HERITAGE AUTO SUBDIVISION

APPLICATION NUMBER 18 DATE October 3, 2013

REQUEST Subdivision

SITE PLAN

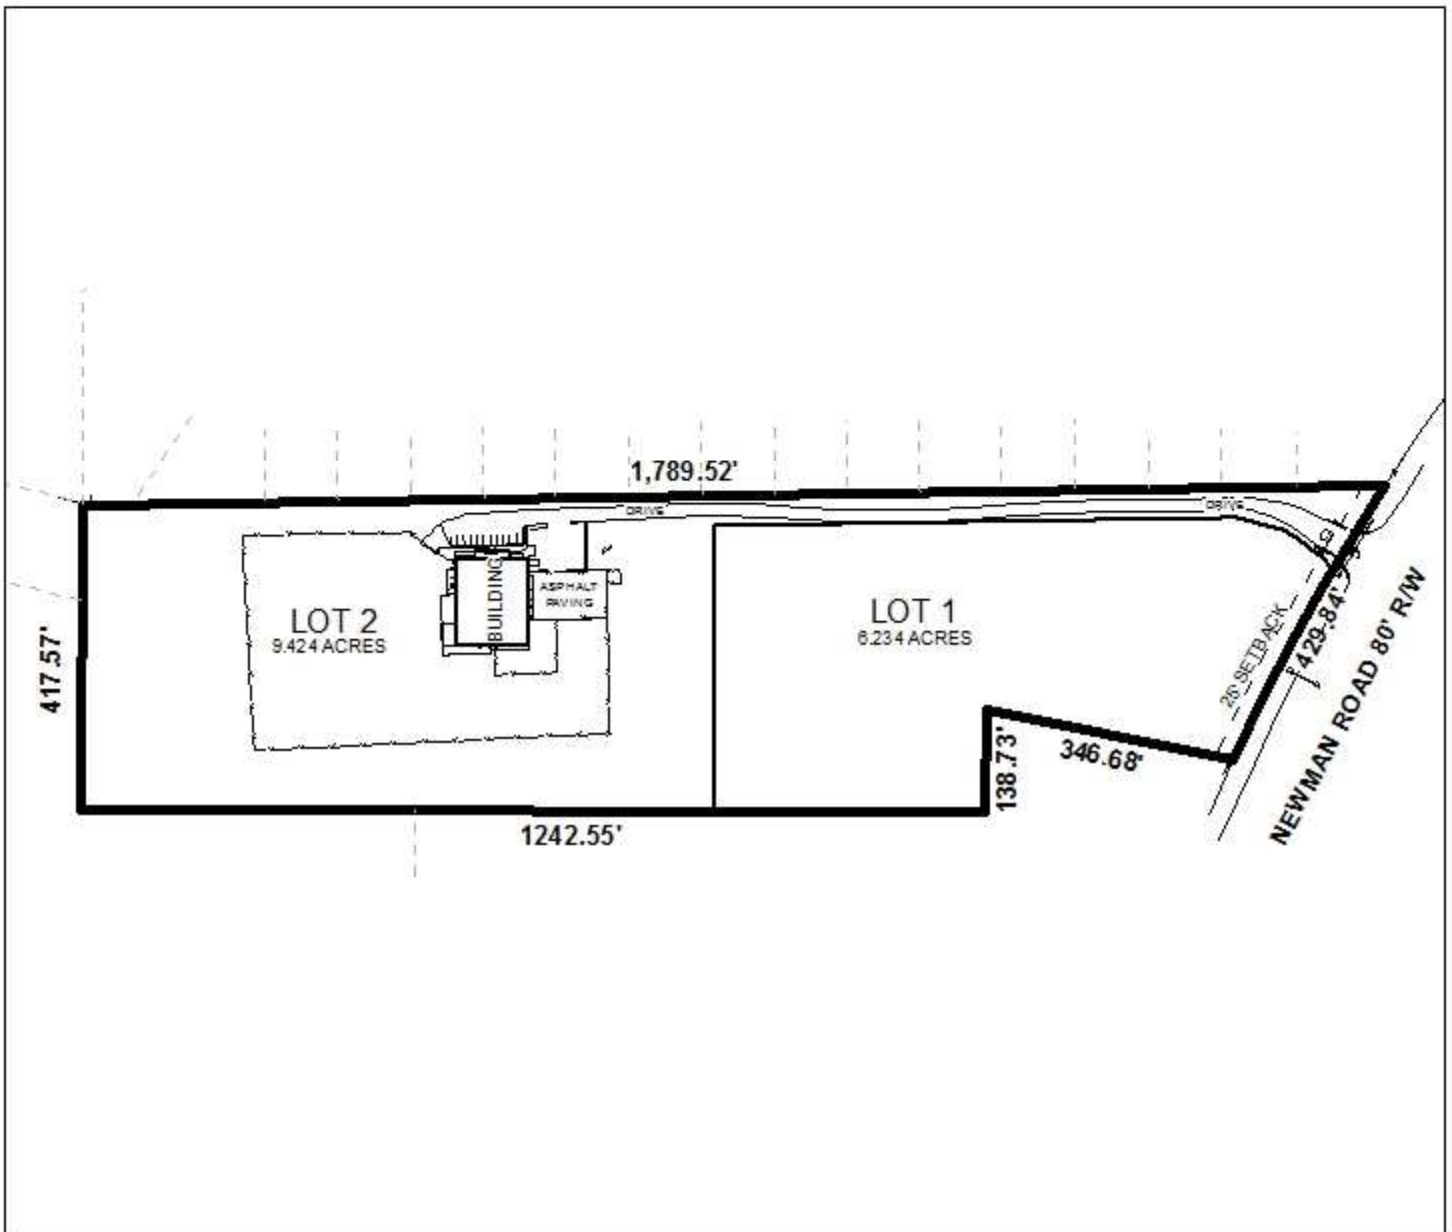
The intent of this application is to create 2 legal lots of record from two metes-and-bounds parcels. It should be noted that both proposed lots are irregular in shape; however, the proposed Lot 2 appears to be a Flag Lot, and the applicant has not provided justification for the creation of a Flag Lot. The Subdivision Regulations govern lot character, and Flag Lots may be permitted by the Planning Commission if in accordance with Section V.D.1. A waiver of Section V.D.1. would be required if the Planning Commission were to approve the request.

In accordance with the Subdivision Regulations, both proposed lots are compliant with the minimum size requirements; however, the proposed Lot 2 would require a waiver of Section V.D.3. for approval due to its depth-to-width ratio. Also, due to the limited frontage provided, a future subdivision of Lot 2 should be prohibited until additional frontage on a public or private street is provided. A note regarding this requirement should be placed on the Final Plat, if approved.

The 25-foot minimum building setback line is depicted on the preliminary plat but should be revised for Lot 2 and depicted as a box where the "Flag" meets the "Pole" of the lot, and retained elsewhere on the Final Plat if approved.

The site has one existing curb-cut which serves as ingress/egress for Lot 2. As a means of access management, if approved, a note should be placed on the Final Plat stating that Lot 2 should be limited to the existing curb-cut and Lot 1 should be limited to one curb-cut along Newman Road with the size, design and location of the new curb-cut for Lot 1 along with any changes to the

existing curb-cut for Lot 2 to be approved by Mobile County Engineering and conform to AASHTO standards.

This site is located in the County, and therefore any lots which are developed commercially and adjoin residentially developed property must provide a buffer, in compliance with Section V.A.8. of the Subdivision Regulations. It appears that a portion of the proposed Lot 2 is already commercially developed and as a result, a buffer should be provided where the proposed lot abuts residentially developed property. Notes and illustration regarding these requirements should appear on the Final Plat if approved.

- 1) The applicant has not provided justification for the creation of a Flag Lot, per Section V.D.1. of the Subdivision Regulations; and
- 2) The proposed subdivision will create a lot which does not comply with Section V.D.3. of the Subdivision Regulations
